PRODUCT CHANGE NOTIFICATION (PCN)

A-MCU60010/Y MODULAR CABLE

PCN 20220509_A-MCU60010/Y

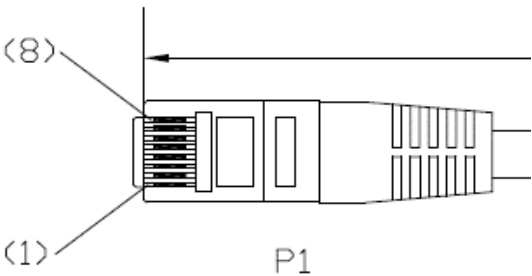
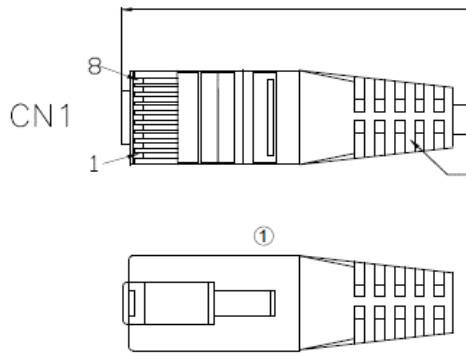
CHANGE OF DATA SHEET
CHANGE OF DATA SHEET
New Draw.-No. ASS_8285_CArev01

CHANGE OF PRODUCT LOCATION
CHANGE OF PRODUCT LOCATION

A-MCU60010/Y	OLD VERSION	A-MCU60xxx/x	NEW VERSION																				
Appearance		Appearance																					
BOM	Material: - Conductor: 26AWG 7*0.16±0.015mm - Conductor Insulation color coding: (1)White/Orange, (1)Orange, (1)White/Green, (1)Green, (1)Blue, (1)White/Blue, (1)White/Brown, (1)Brown - Included printing on cable jacket: CM (UL) C(UL) 4P 26AWG UTP CAT.6 PATCH CABLE ISO/IEC & EN & ANSI/TIA-568-C.2 - Cable Assembly: White cable tie, Wiring T568B color, Plug RJ45 8P8C 3μ pc UL 94V-2 - Cable Jacket color: Grey	BOM

<table><tr><td>①</td><td></td><td>Molding PVC</td><td>2</td><td>Molding PVC 65P</td></tr><tr><td>①</td><td></td><td>RJ45 CONN</td><td>2</td><td>RJ45 8P8C, contacts 3u" gold-plated Un-shielded PC UL94V-2</td></tr><tr><td>①</td><td></td><td>CABLE</td><td>1</td><td>CAT6 U/UTP(26AWGx1PR)*4+Cross+PVC Jacket OD:5.0±0.3mm</td></tr></table>
